Whine Noise From Rear of Vehicle

Service Category Drivetrain

Section Axle/Differential

REVISION NOTICE

Figure 4.

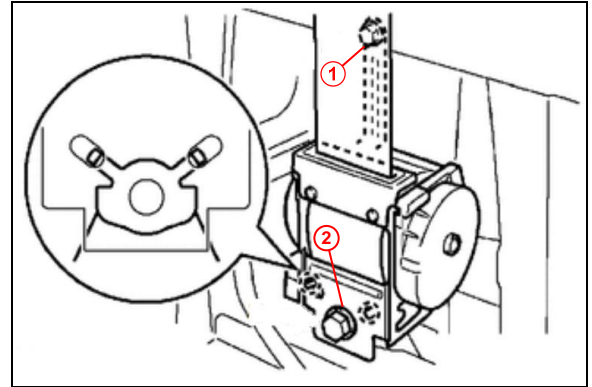
F. Torque the seat belt bolts.

Bolt A

Torque: 12.5 N*m (127 kgf*cm, 9 ft*lbf)

Bolt B

Torque: 42 N*m (428 kgf*cm, 31 ft*lbf)

Figure 6.

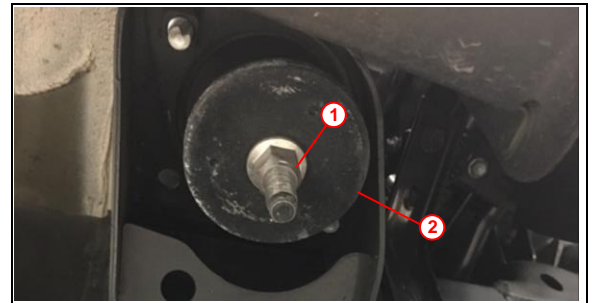
A. Remove the No. 3 nut cab mount (17 mm) and LH and RH cab mounting cushion stopper.

Figure 7.

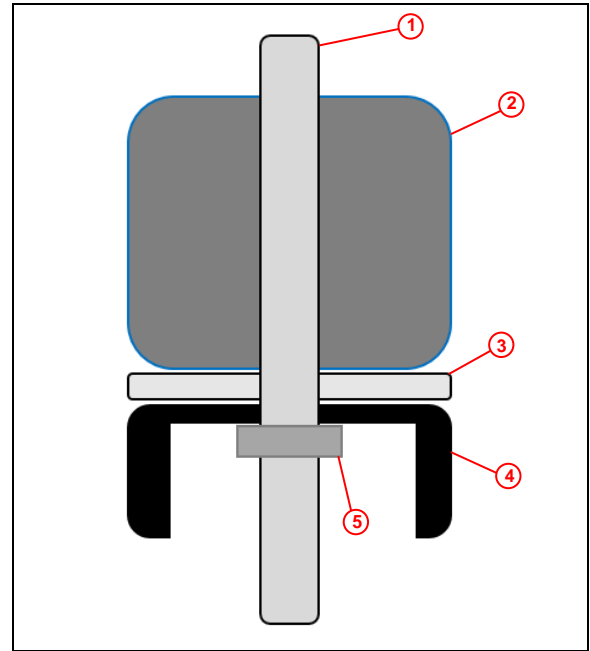
- B. Install the NEW cab mounting cushion stopper and the NEW frame dynamic damper to the RH and LH cab mount.
- C. Retighten the cab mount nut.
Torque: 45 N*m (459 kgf*cm, 33 ft*lbf)
